JFM Environmental Limited

Project 20-2-1832-64-A.1

RE: Response to Email - Review of Previous Hydrogeological Work
Poplar Woods Development - Phase 2
Part of Lots 5 & 6, Concession 8 (Lobo), Ontario

FIGURE 9

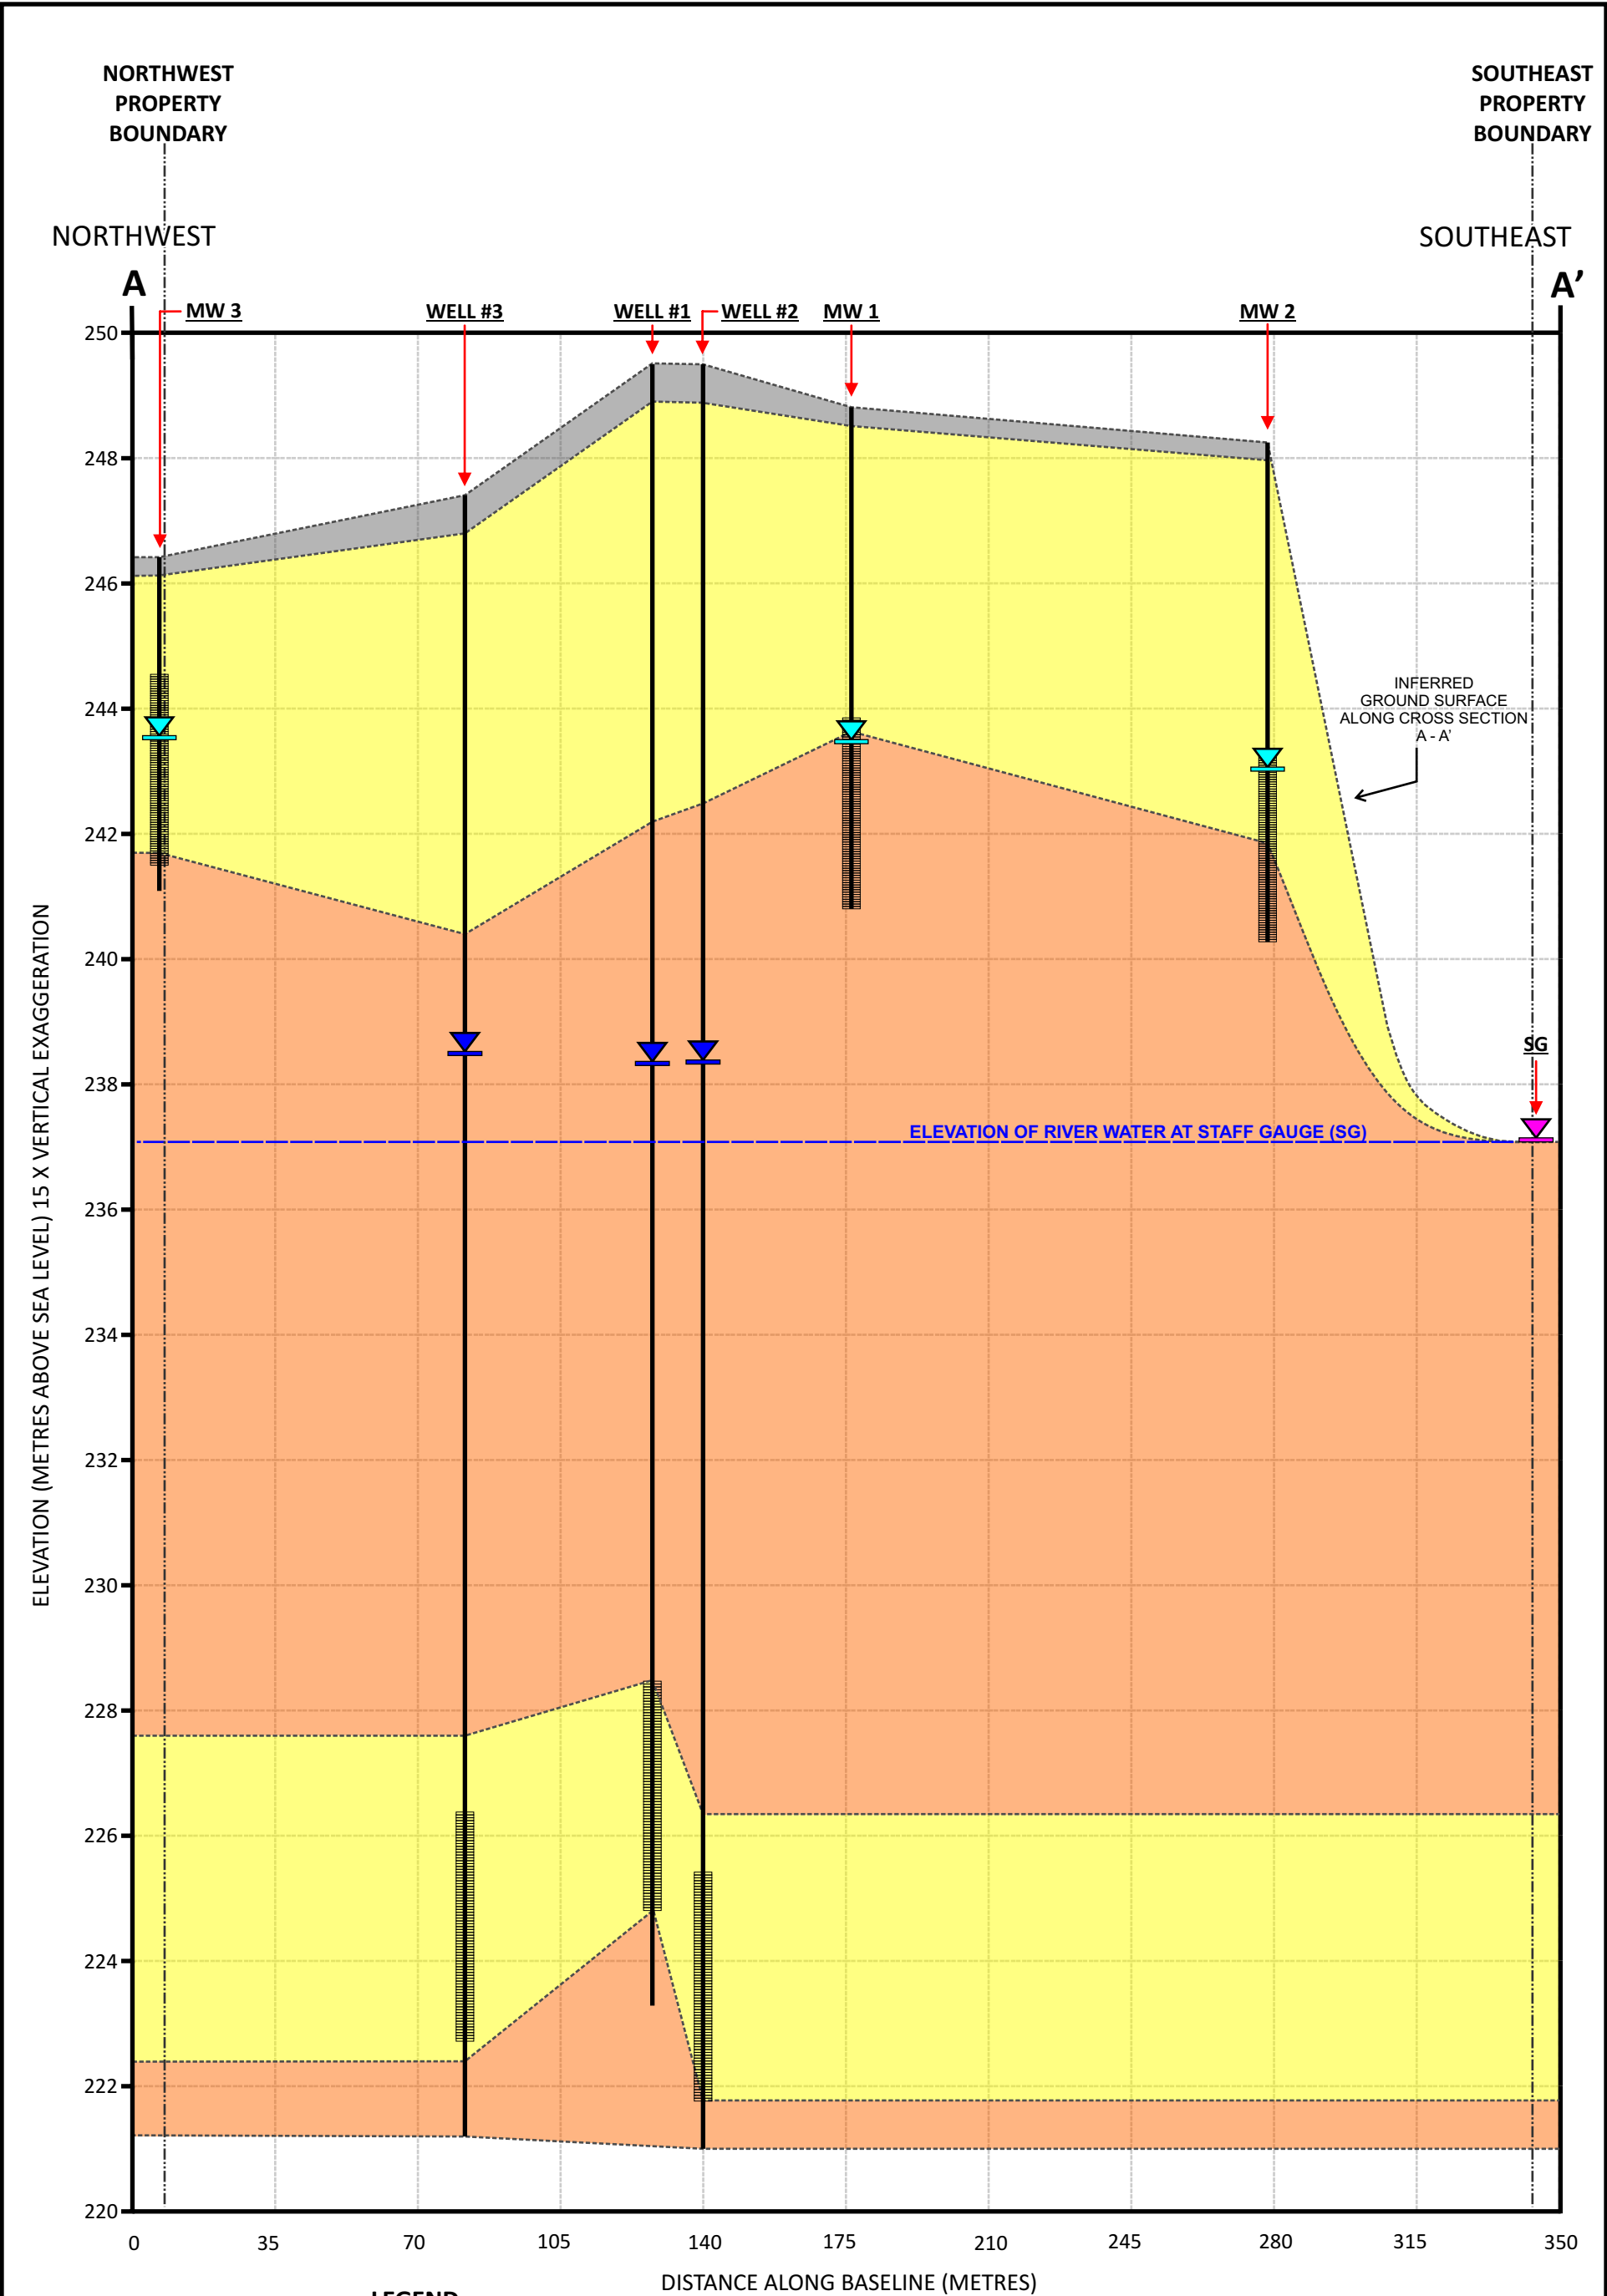
- 1) "The restriction of road salt within the development has been proposed as a mitigation measure in the JFM addendum dated April 20, 2018. Further details regarding the implementation within the plan of subdivision is required."; and,
- 2) "The Municipality must determine if the information provided to date is sufficient to address the potential risk associated with the provision of services with regards to the separation between the upper and lower aquifer."; and,
- 3) "The addendum report by JFM Environment, dated April 20, 2018 discusses the disposal of grey water, please confirm the report also addresses black water.

On Page 4, under the heading of Cross Contamination Between the Two Aquifers in the JFMEL Response, April 20, 2018 the following is noted. "Since 2015, the concentration of sodium in the shallow groundwater measured at MW1, MW2 and MW3 has substantially decreased. For example, in 2015, the sodium concentration at MW3, located next to Ilderton Road was 95,600 mg/L ; in 2017, the sodium concentration in the groundwater at that well was reported to be 73.6 mg/L. These concentrations suggest that between 2015 and 2017, the amount of road salt applied had dropped significantly. This assumes that the sodium concentration at MW3 are mostly from the application of road salt. MW3 is located near the roadside ditch which will convey stormwater that seeps into the ground and presumably into the shallow groundwater (upper aquifer)." Figure 9 shows well locations.

In the JFMEL January 15, 2018 report, the stratigraphy of the overburden of the Site was described based on water well records within 500 m of the Site from the Ministry of the Environment, Conservation and Parks (MECP), or at the time of the completion of the report, The Ministry of the Environment and Climate Change (MECC) database and from on-Site drilling of monitoring wells (stratigraphy logged by JFMEL personnel) and water wells (with stratigraphy as recorded by the water well drillers at the time of installation of the wells). For the JFMEL January 15, 2018 report, which is JFMEL's most recent hydrogeological report, 204 water well records were reviewed. The following descriptions of the Site stratigraphy and interpretation of the on-Site hydrogeology were included in this report. The interpreted stratigraphy is shown in the cross-sections, Figures 9A and 9B from Reference 3. Figure 9 shows the locations of the lines of cross-section in Plan view.
